April 16, 2010  
NRC3-10-0016

Subject: Detroit Edison Company Response to NRC Request for Additional Information Letter No. 25

**Response to RAI Letter No. 25  
(eRAI Tracking No. 4339)**

Figure 2.4-265 Wave Run-Up (Vertical exaggeration is approximately 5 to 1)

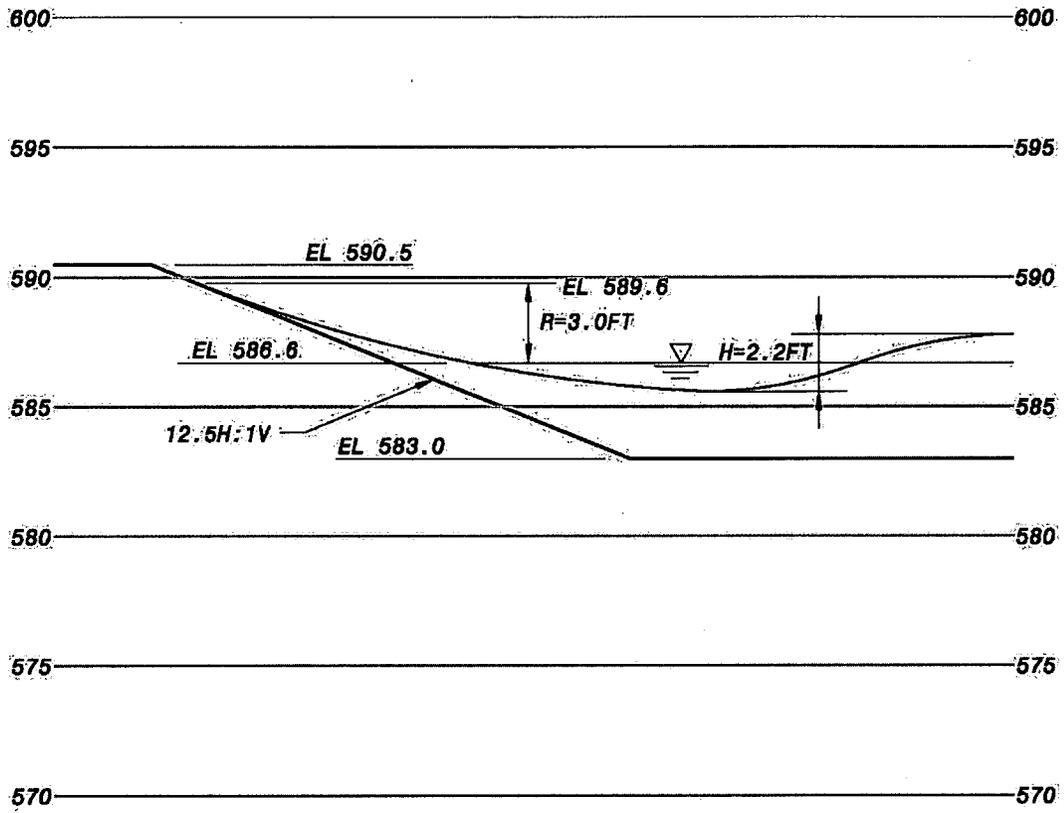
FSAR Sections 2.4.3 and 2.4.5 along with FSAR Figures 2.4-263, 2.4-264, and 2.4-265 have been updated to reflect the analysis as presented in response to NRC RAI Letter No. 19.

Wave run-up for Alternative III is predicted to be 3.0 ft, or approximately 0.85 feet below the elevation of the Fermi 3 safety related structures. Wave run-up is shown on Figure 2.4-265. The vertical exaggeration on Figure 2.4-265 is approximately 5 to 1. For Alternative II the still water level at the site was calculated to be 578.6 ft NAVD88 or 579.8 ft PD. This elevation is about 3.2 ft below the elevation of the top of the seawall at the site. For this alternative, there would be water from the waves splashing up onto the onshore area behind the seawall. The still water level for Alternative IA would be 581.7 ft NAVD88 or 582.9 ft PD, which is just below the top of the seawall. A significant amount of water would wash onto the onshore area. The elevation of the safety related structures is 7.5 ft above the onshore area. Based on this information, it was concluded that wave activity would not have any impact on the safety related structures for any of the alternatives considered.
